ADDENDUM NO. 1

October 3, 2024

Whiteland High School Ph 2: Café Kitchen Band Choir Auditorium
300 E. Main Street
Whiteland, IN 46184

SHEET 902

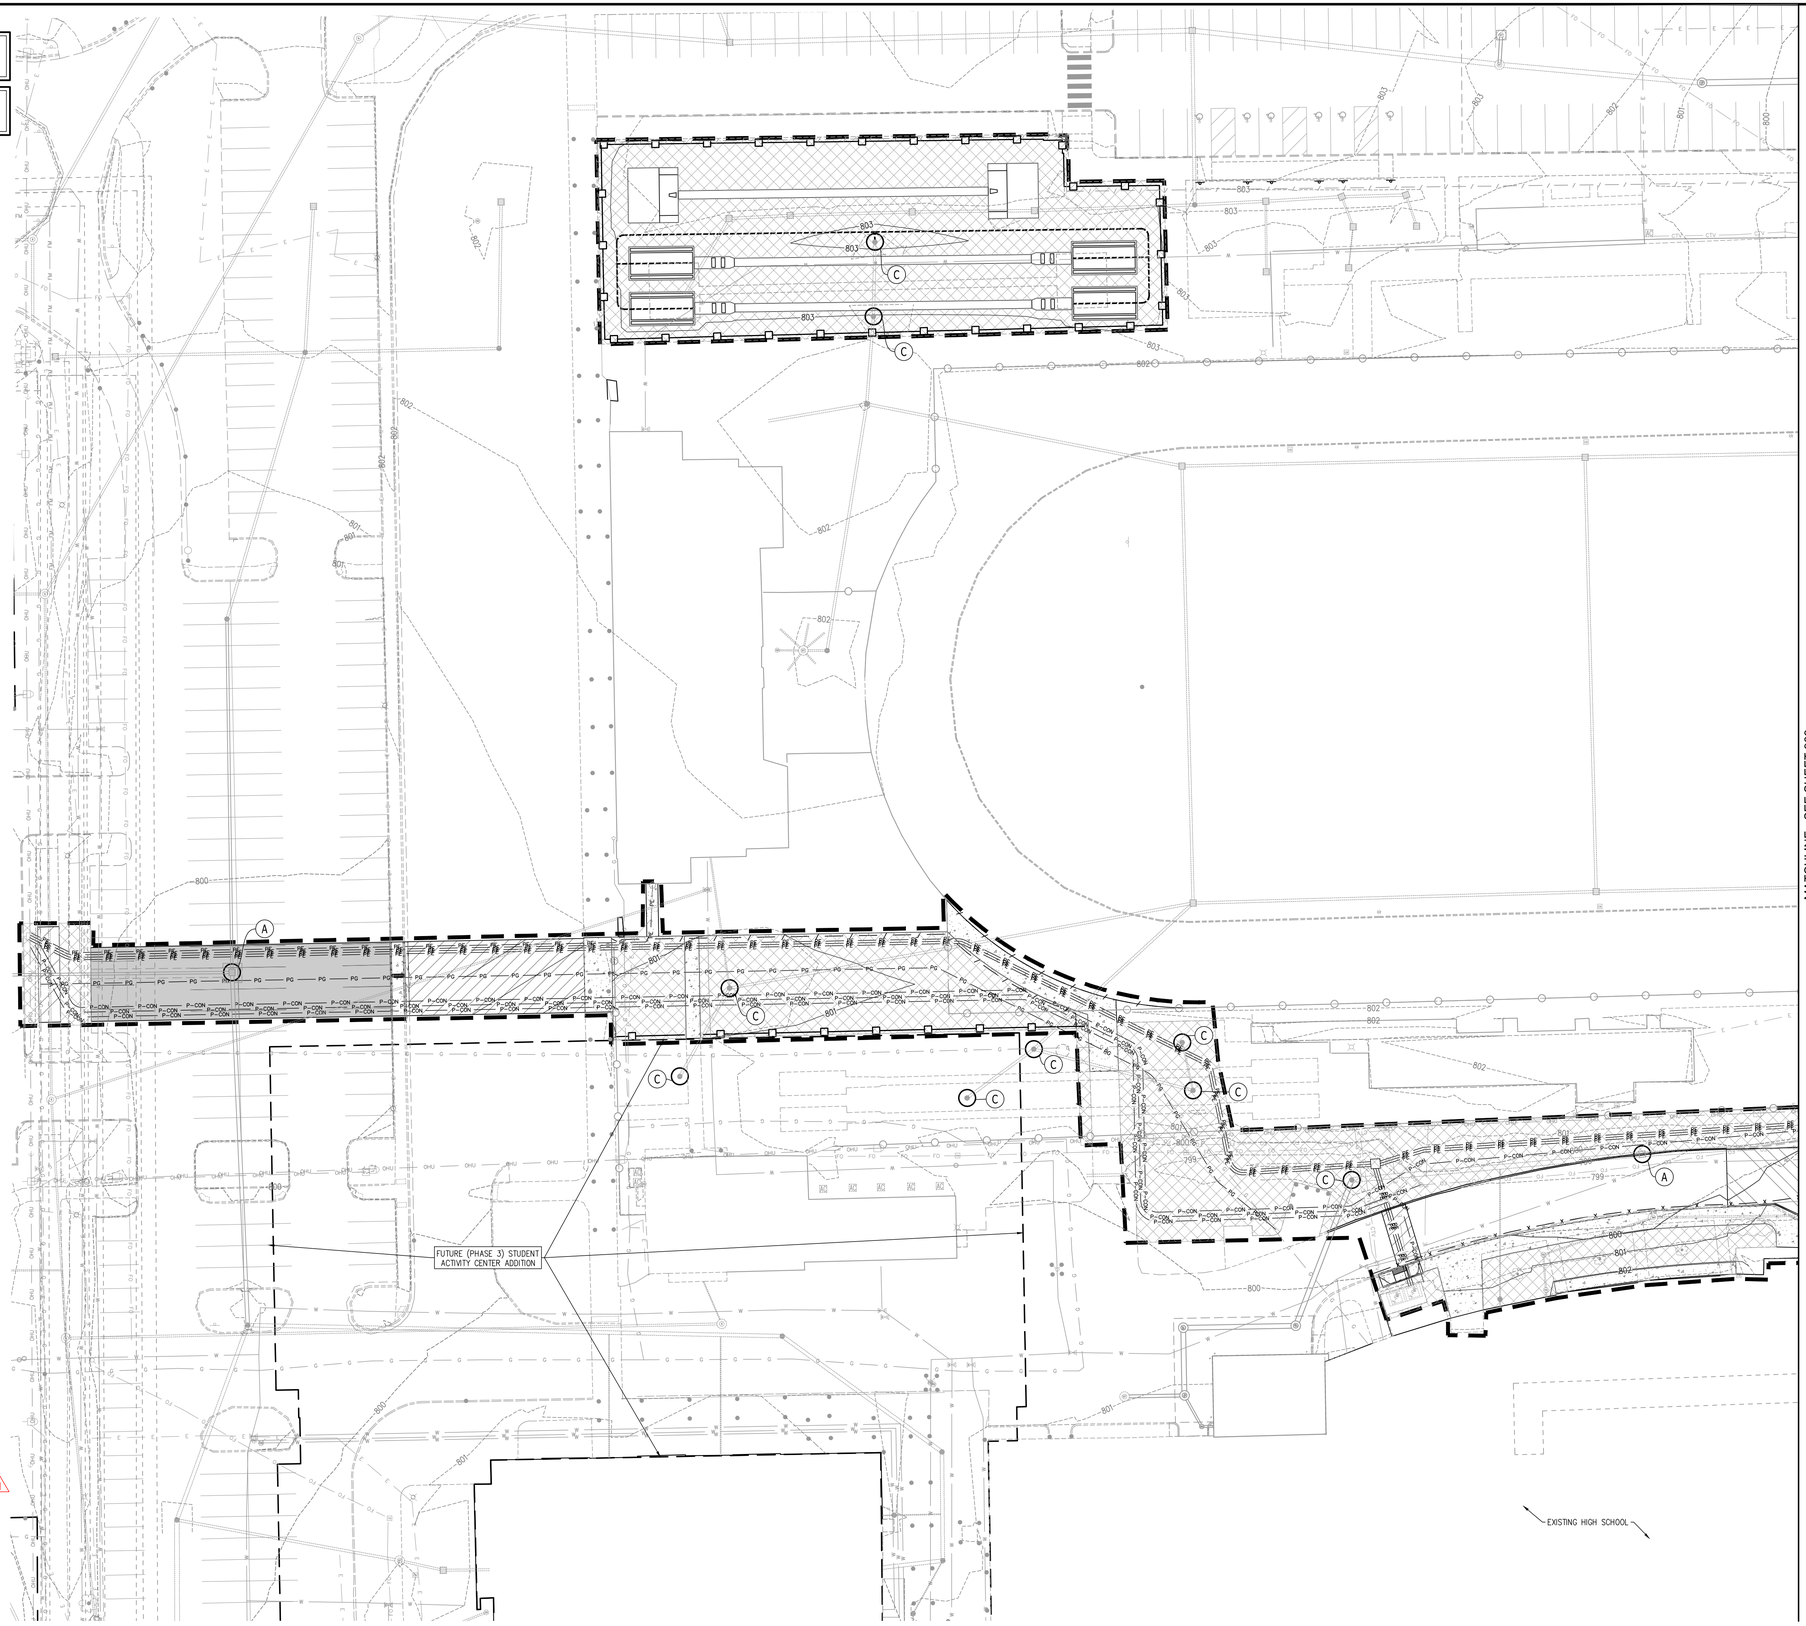
12. Erosion Control Plan (sheets 901, 902, and 904)
- Added note #6 to Erosion Control Notes regarding street sweeping.

CURB RAMP DETAIL A
SCALE: 1"=10'

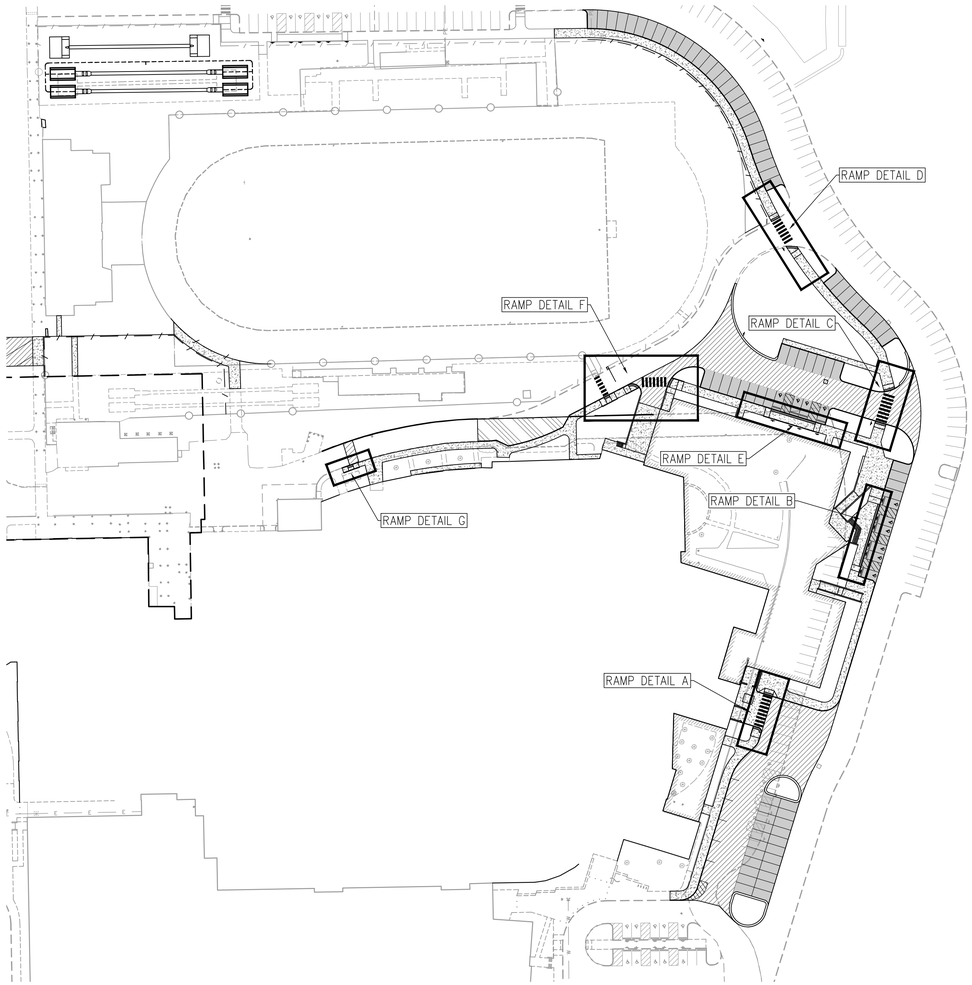
15. Curb Ramp Details (sheet 1003):
- Revised curb ramp details 'A', 'D', and 'F' to correctly show grade breaks and integral concrete return curb.

1 DEMOLITION PLAN - FIRST FLOOR - UNIT A
SCALE: 1/8" = 1'-0"

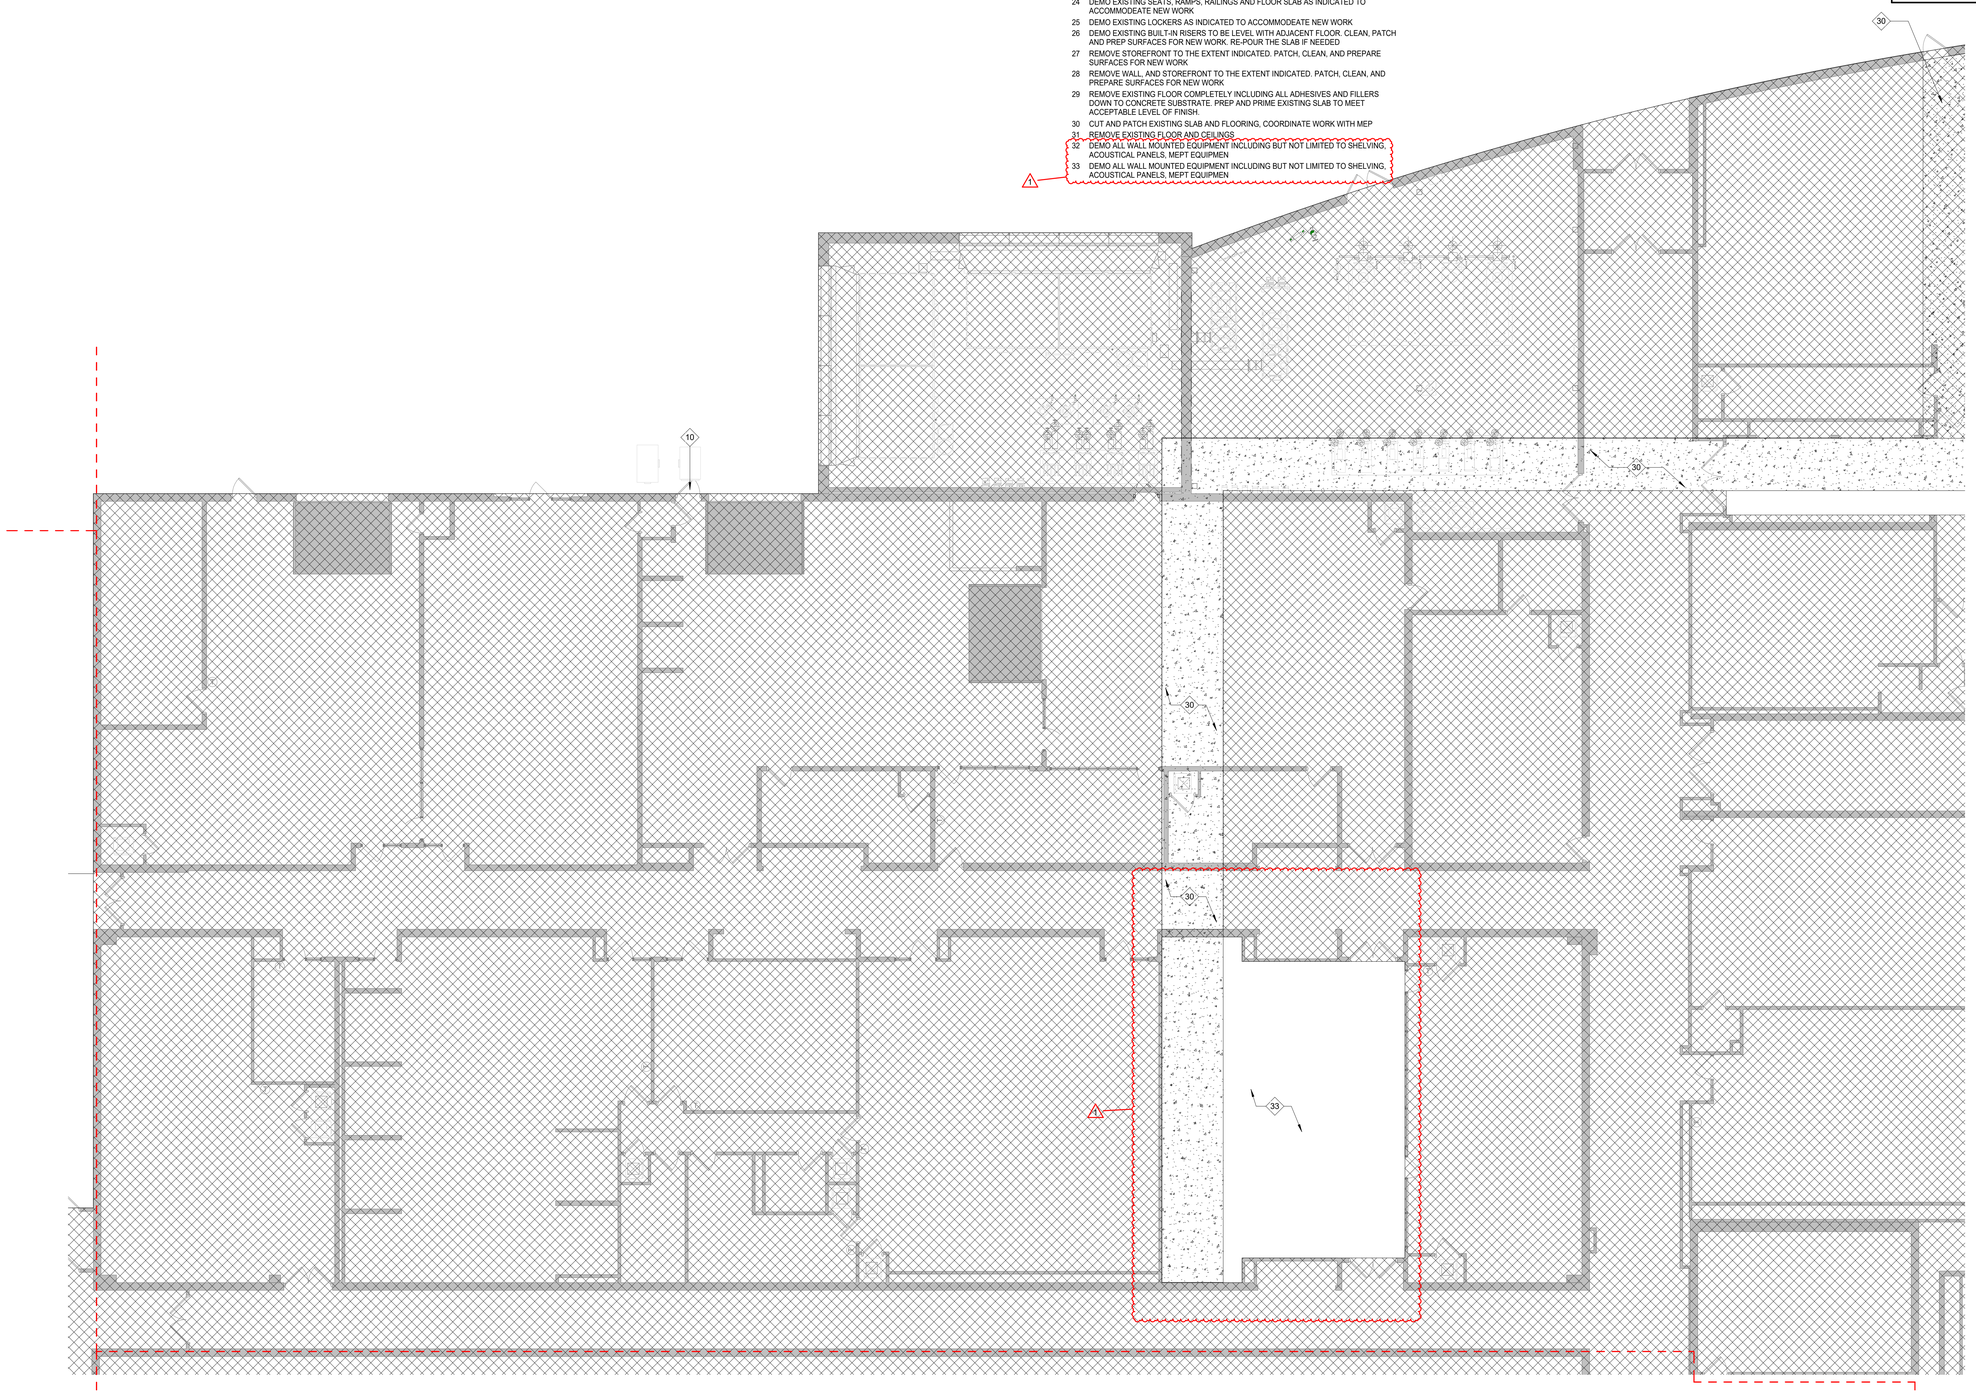
19. Sheet AD101A – DEMOLITION PLAN – FIRST FLOOR – UNIT A
- Changed notes about floor demolition

5 AUDITORIUM WEST ELEV EAST ADDITION
SCALE: 1/8" = 1'-0"

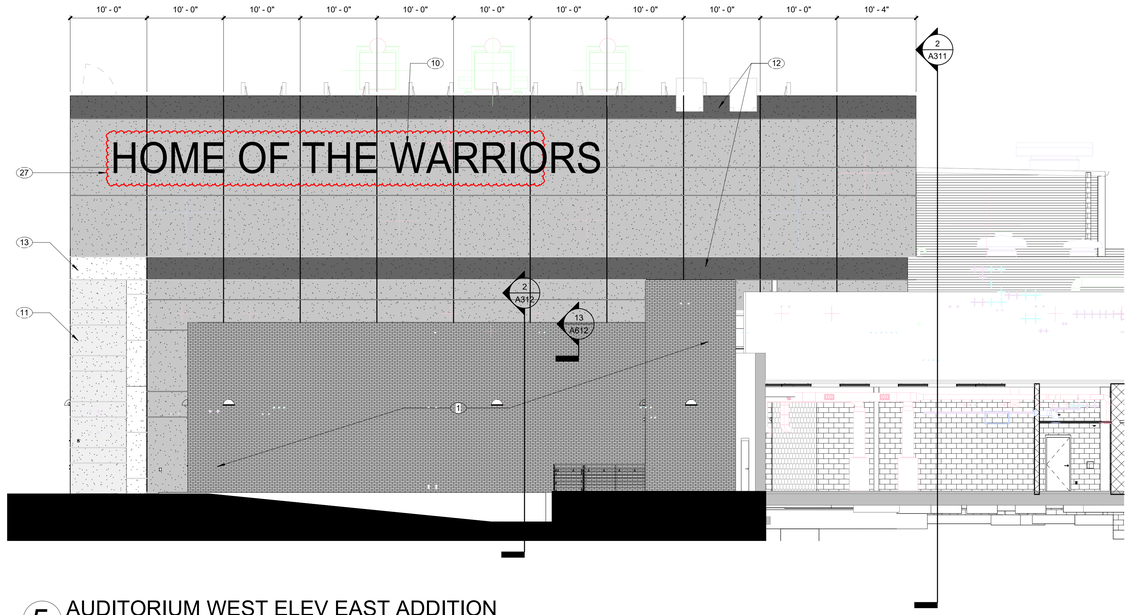
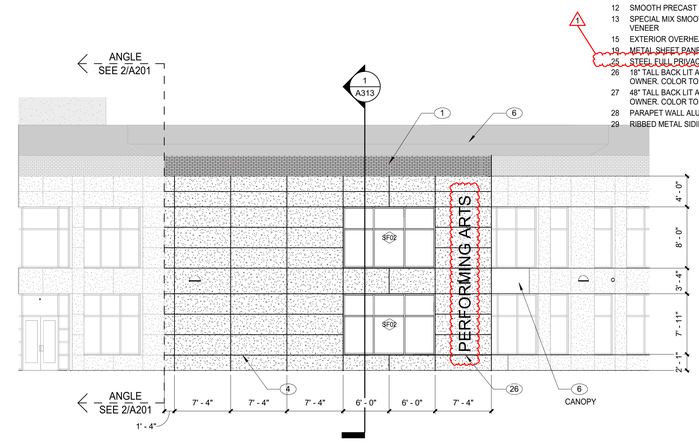
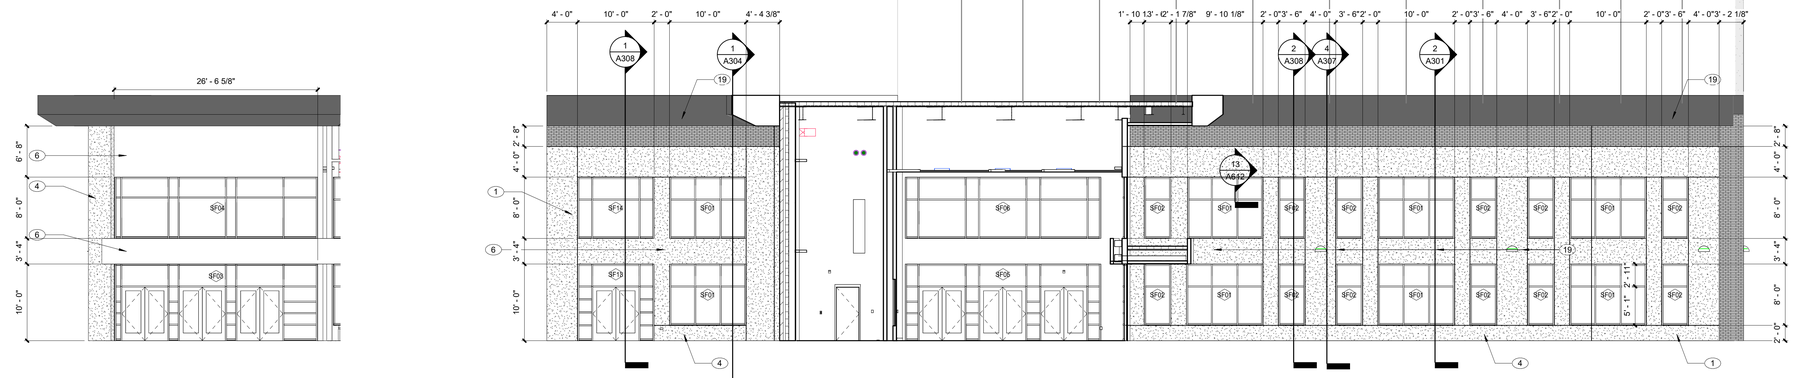
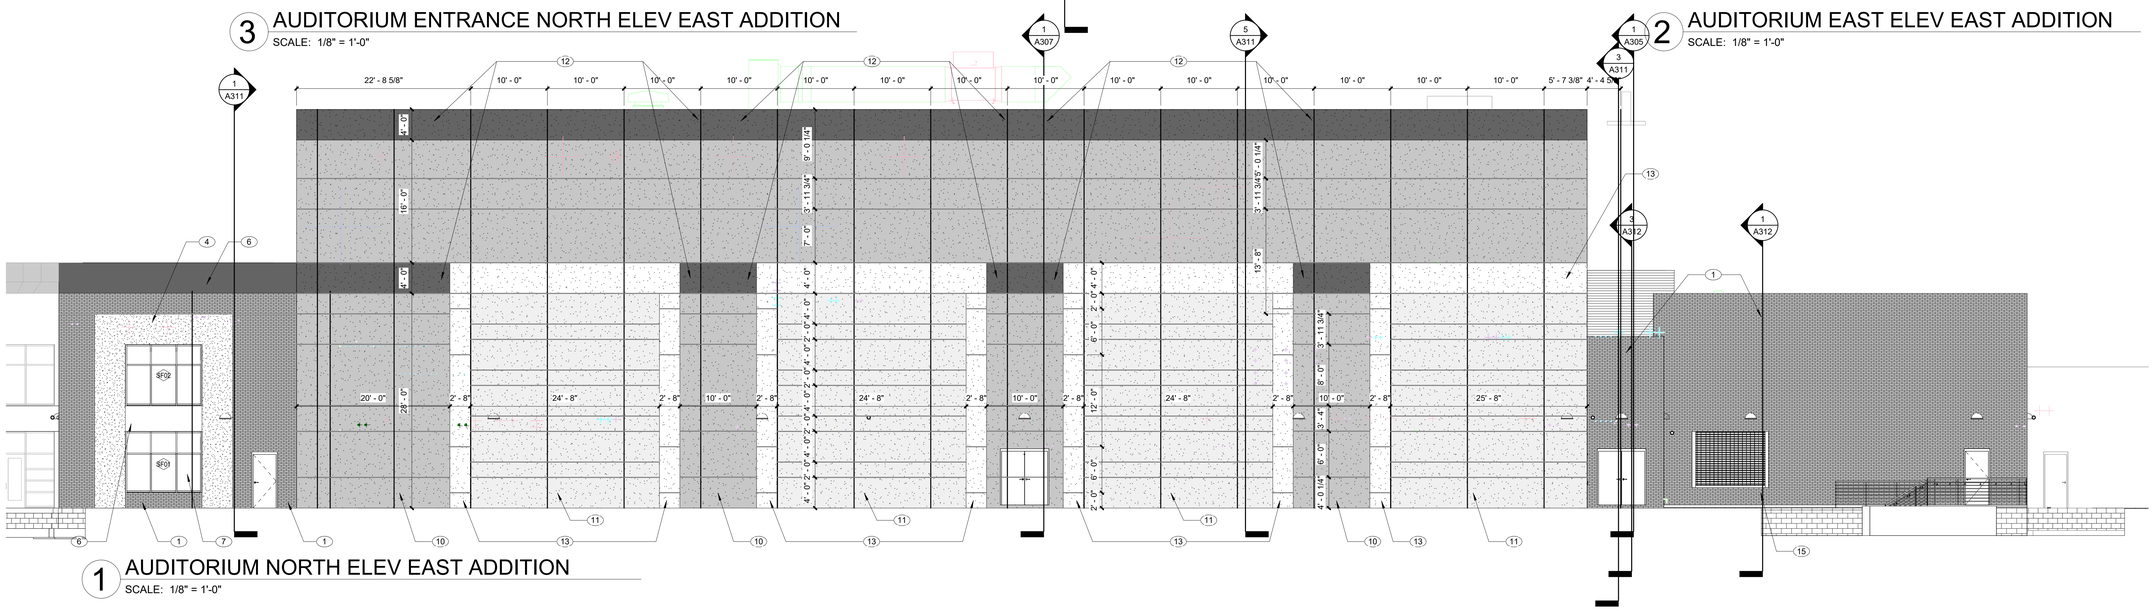
22. Sheet A201 – ELEVATIONS
- Added text to show the extent of signage
- Changed note 25 to say "STEEL FULL PRIVACY GATE"
